SITE PLAN REVIEW *Comments due 4/5/96*

Project Name: All Sports Honda

FILE #SPR-96-67

TITLE HEADING: Site Plan Review - All Sports
Honda

Site Plan

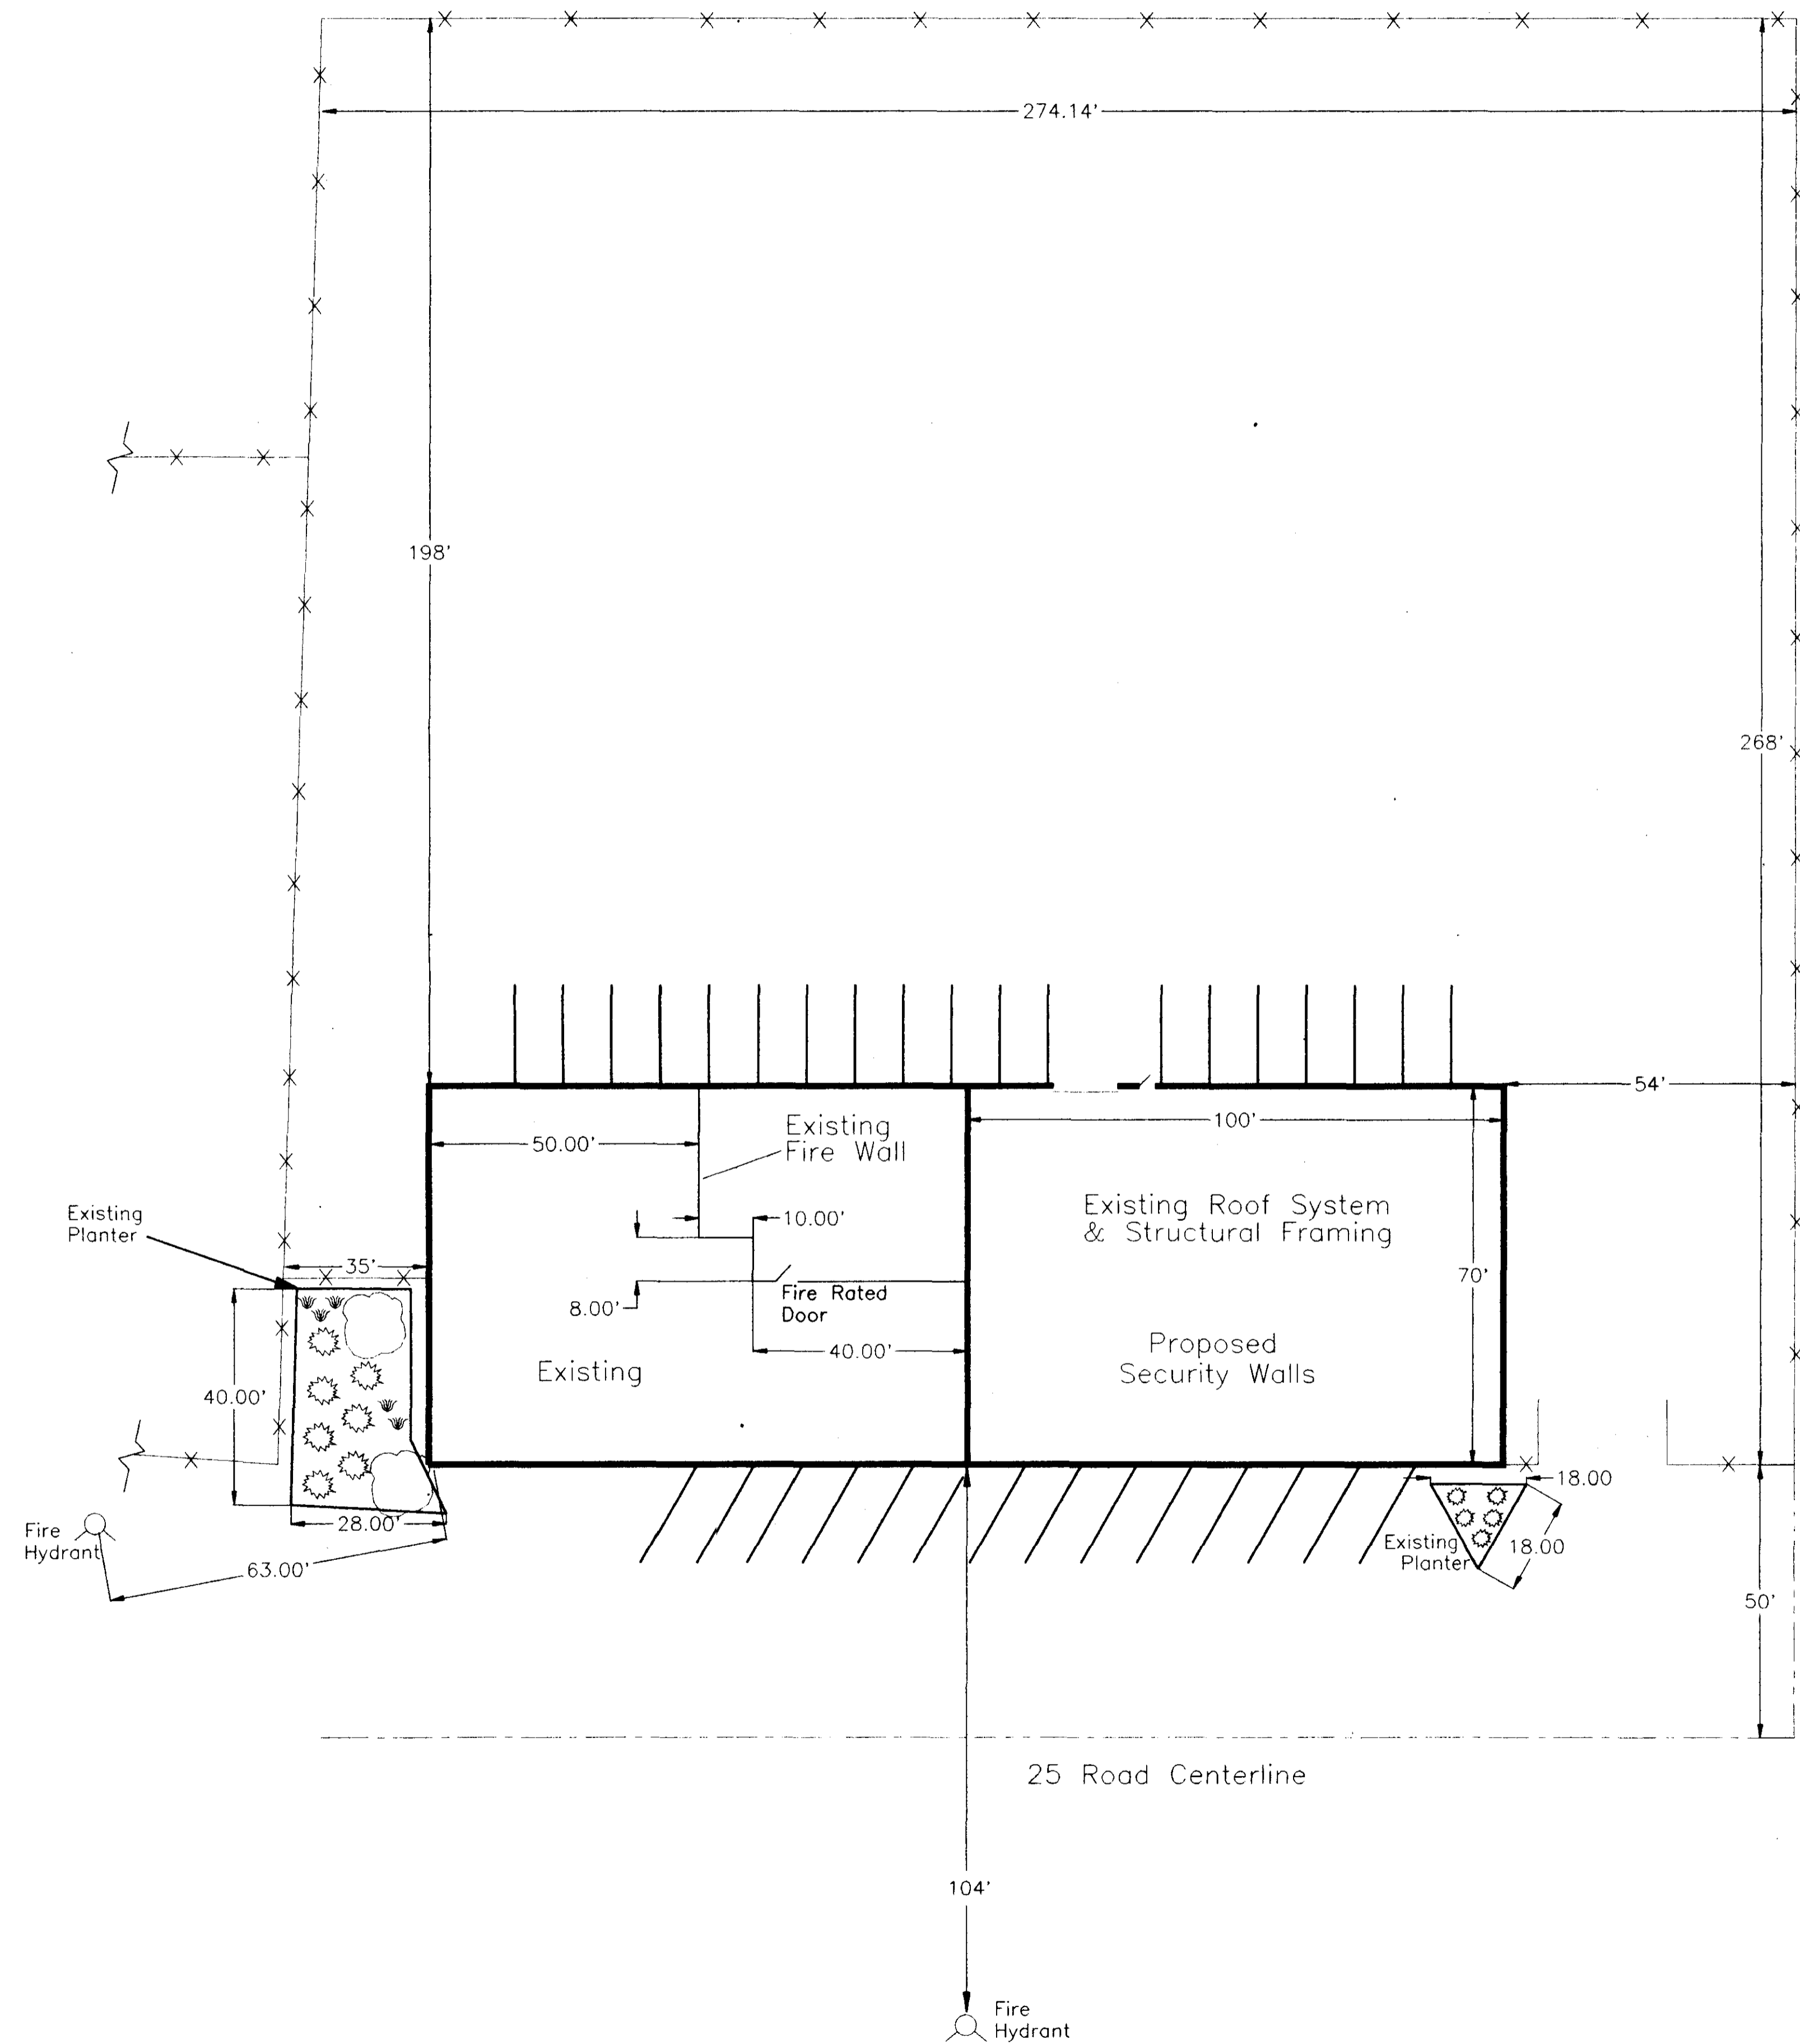
1. The parking, as it exists in front of the building, does not meet Code requirements because vehicles must back into the street to get out. However, since the proposed project is to only enclose an existing storage area the parking can remain as it is for now. Any future change in use of the area being enclosed from storage to some other use, such as retail, shop or office, will require further review of the parking. Future plans to widen 25 Road will necessitate the redesign of the parking.
2. Indicate the type of plantings proposed for the planters. The larger planter should contain one tree and have 40% shrub coverage. The smaller planter must meet the 40% shrub coverage requirement. Indicate how the plantings will be watered.

+++City Community Development, Kathy Portner+++
See attached revised plans for landscaping requirement.

-  PINYON PINE (*Pinus edulis*) Quantity: 2
minimum caliper 1 1/2 in. (12 - 15 ft. at maturity)
-  RUBBER RABBITBRUSH (*Chrysothamnus nauseosus*) Quantity: 5
minimum 5 gallon size (4 - 6 ft. at maturity)
-  JUNIPER (*Juniperus horizontalis*) Quantity: 12
minimum 5 gallon size (1 - 2 ft. at maturity)

Note: Above plants are suitable for very low water zone and once established little irrigation will be required. Supplemental hand water will be used during the first growing season to establish plantings.
